This is to certify that JAHNS HANS O & SUSE JAHNS JTS/Dave Keeney Builders Inc.
has permission to re-frame roof to increase pitch & eliminate leak problem
AT 17 CHENERY ST CBL 129 H007001
City of Portland

Proposed Use: Single Family Home - re-frame left hand section of roof to increase pitch & eliminate leak problem	Proposed Project Description: re-frame left hand section of roof to increase pitch & eliminate leak problem
---	--

Permit Application for Roof Alteration

Figure 2: Planned Roof-Lines
 (Modifications shown in red)

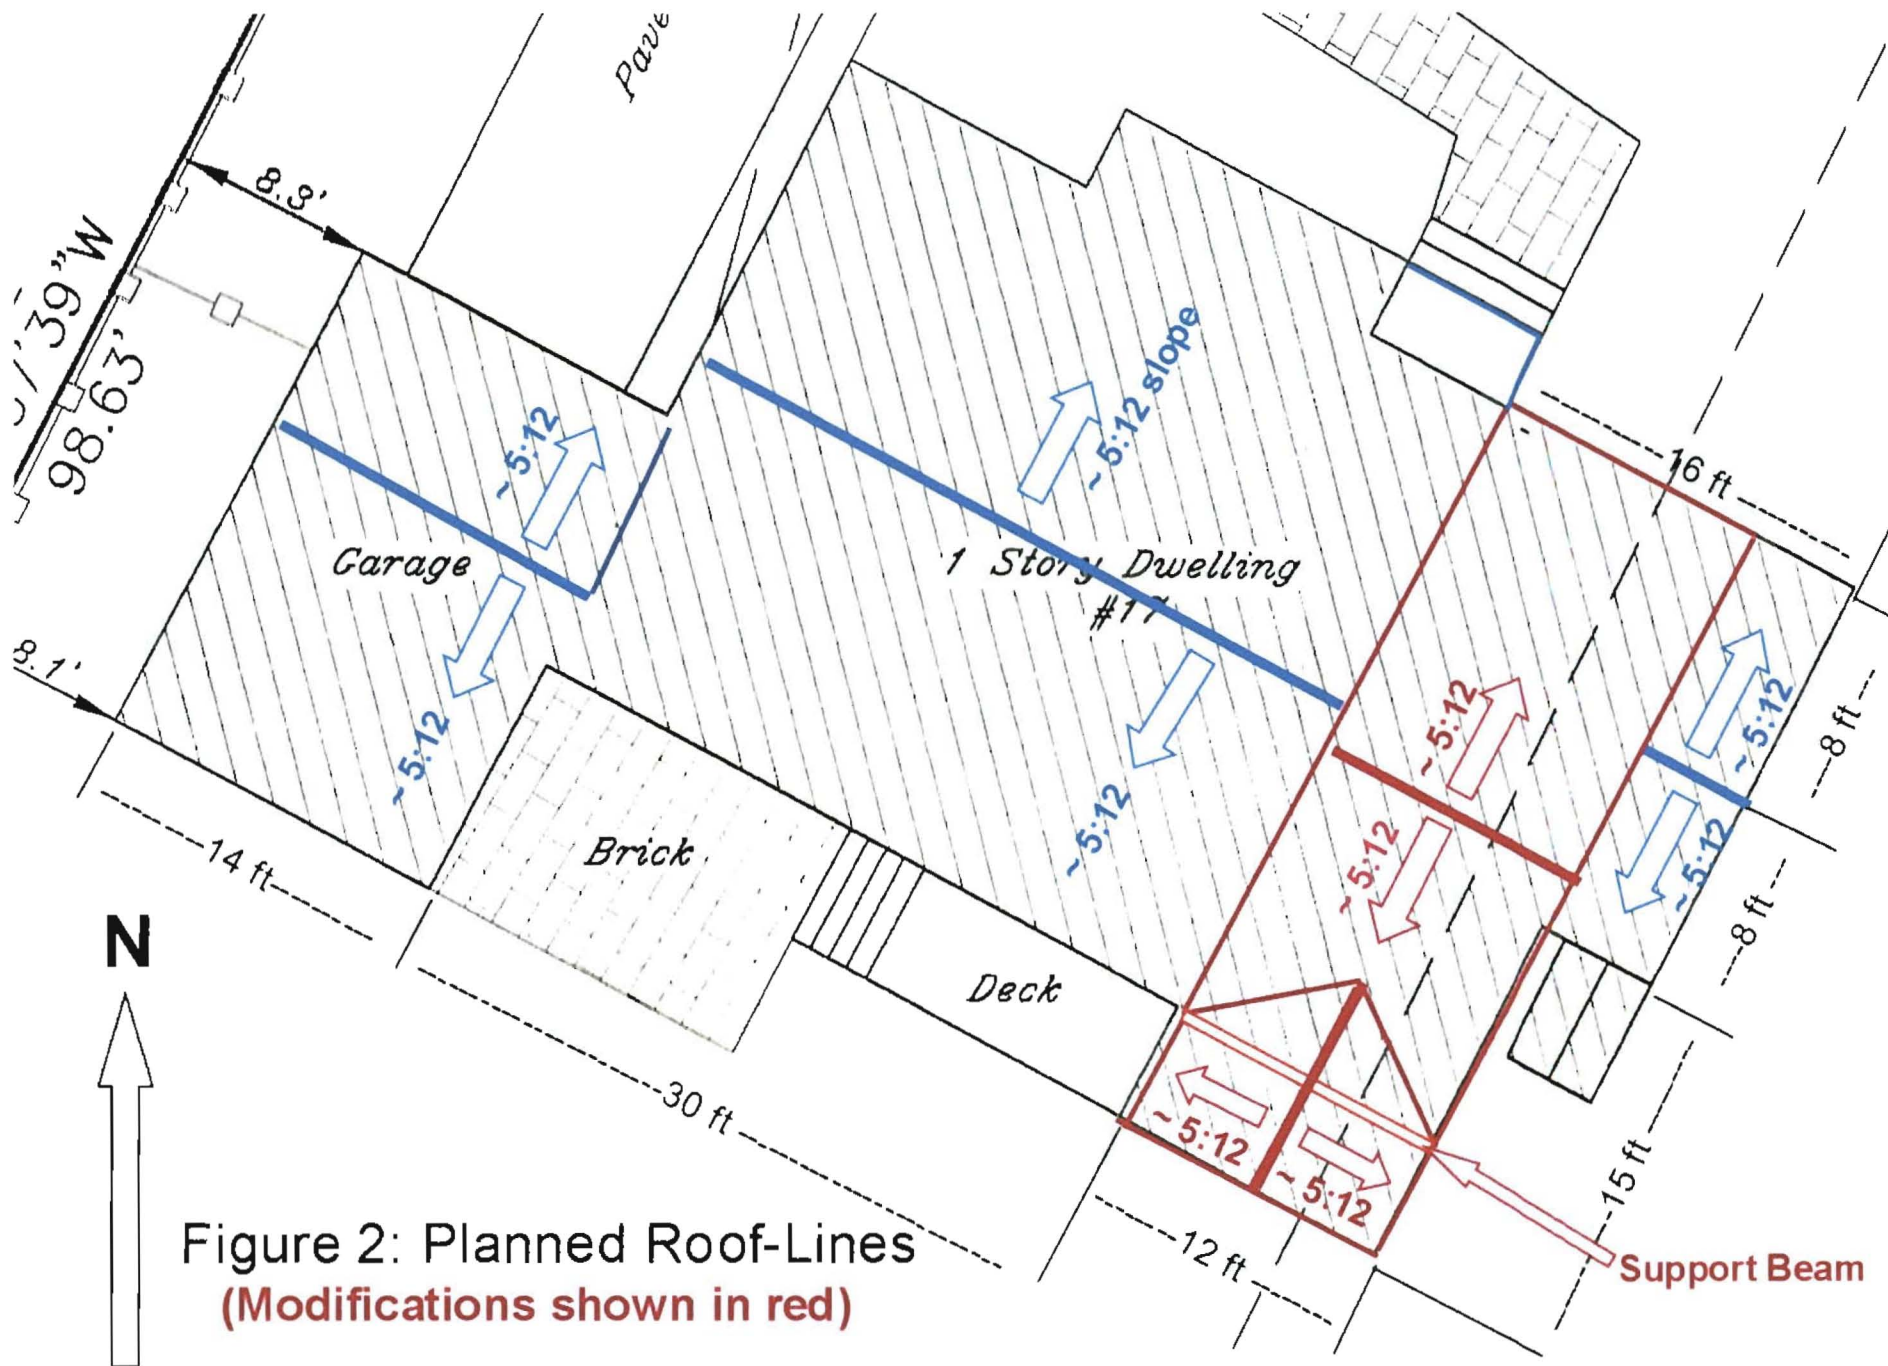
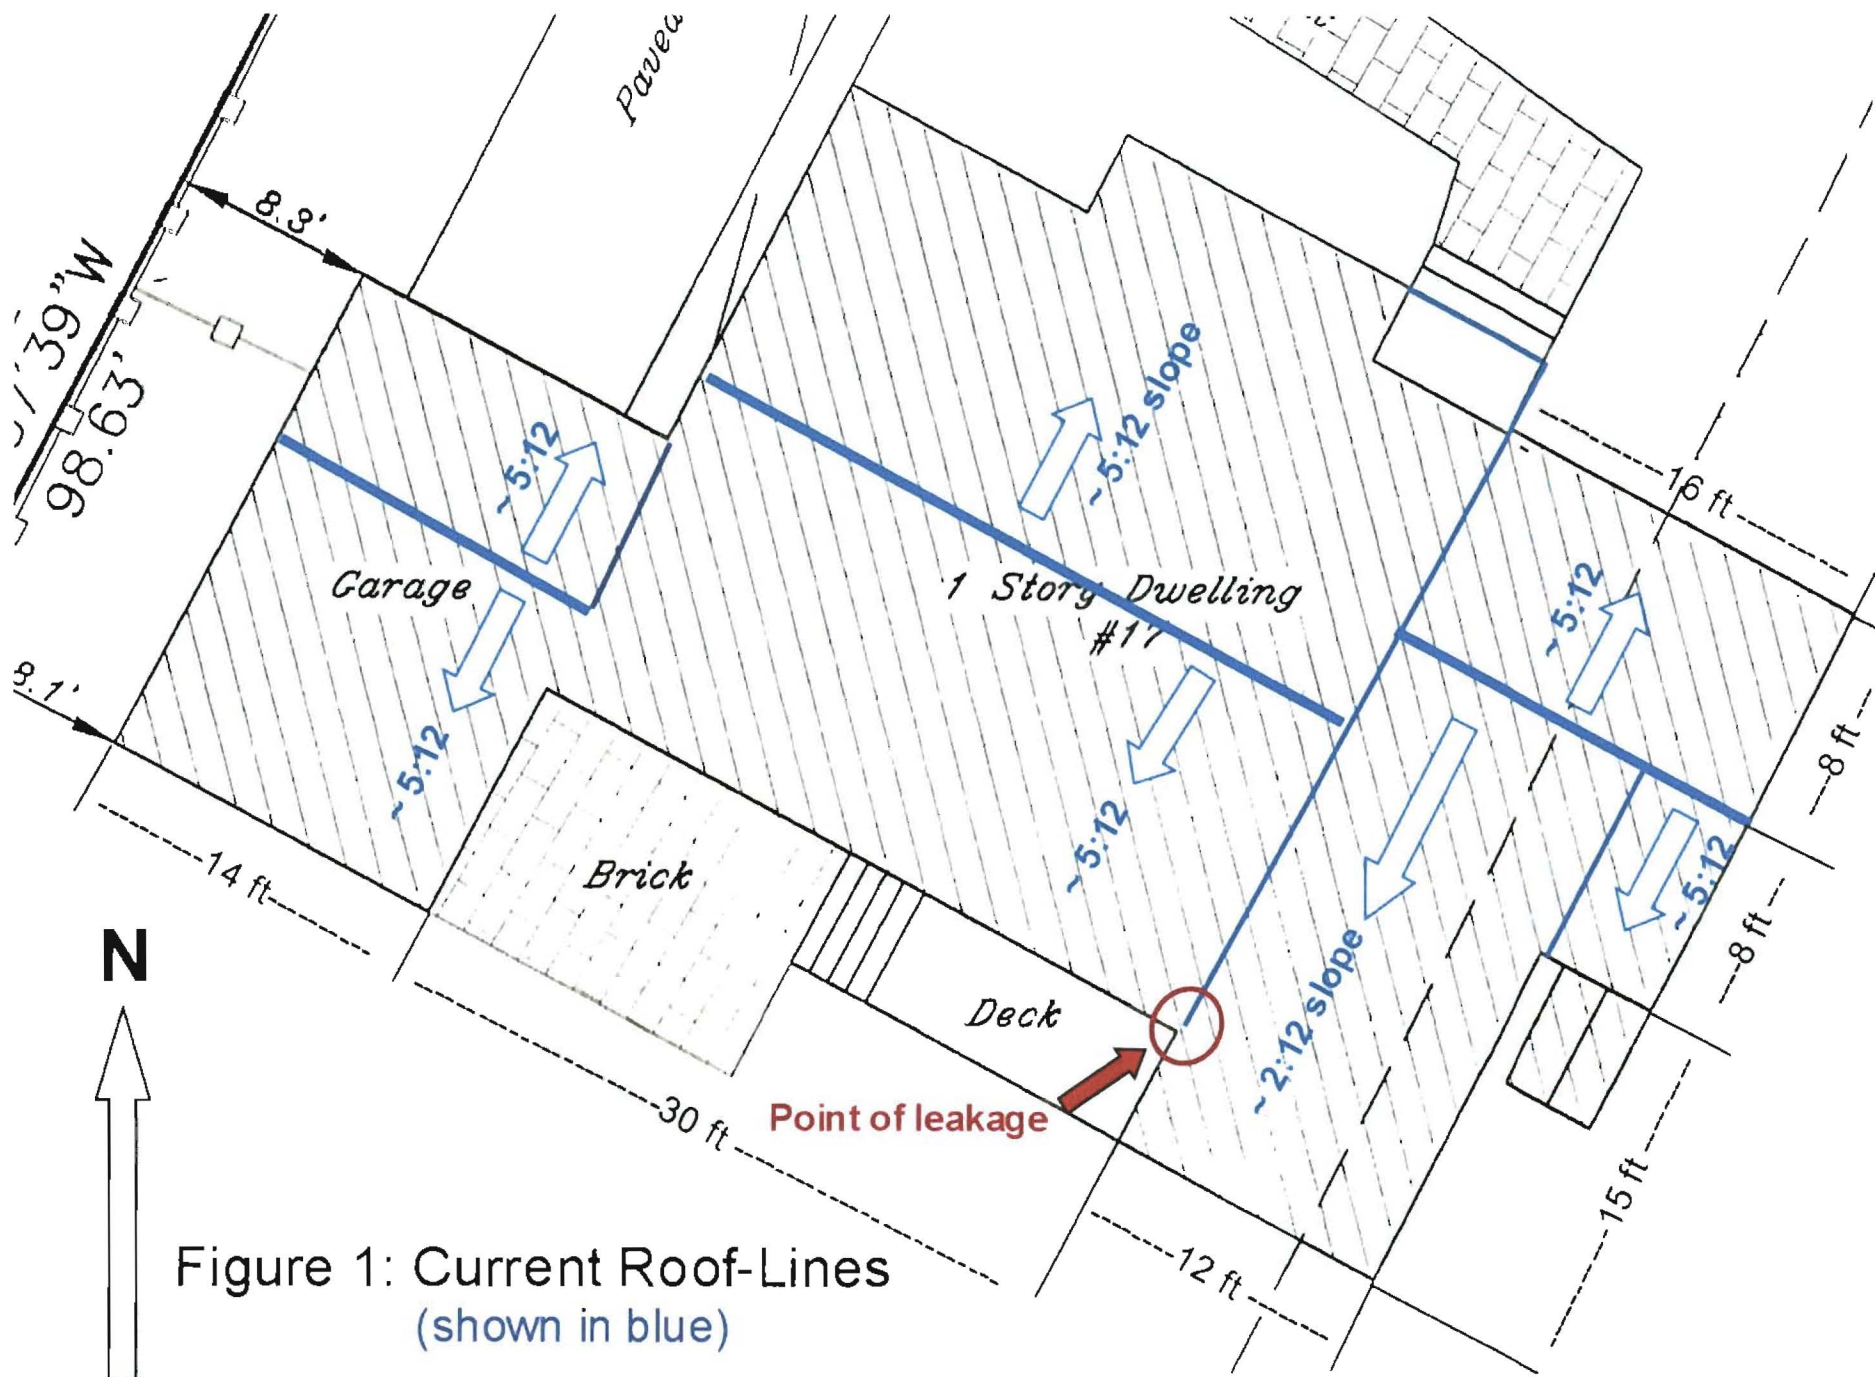
9/10/2010-jrioux: Lft. Msg with Contractor, i.e 2X14" rafters & specs for LVL.

9/13/2010-jrioux: Contractor stated 2X10" @ 16" O/C will be used for a 12ft span; need detail for postive connection for LVL.

10/6/10 Met w/Dave K. in office. Submitted Eng
Lam Spec - Reviewed Rafter sizing
2x10 @ 16" oc meets both spans of Roof JMB
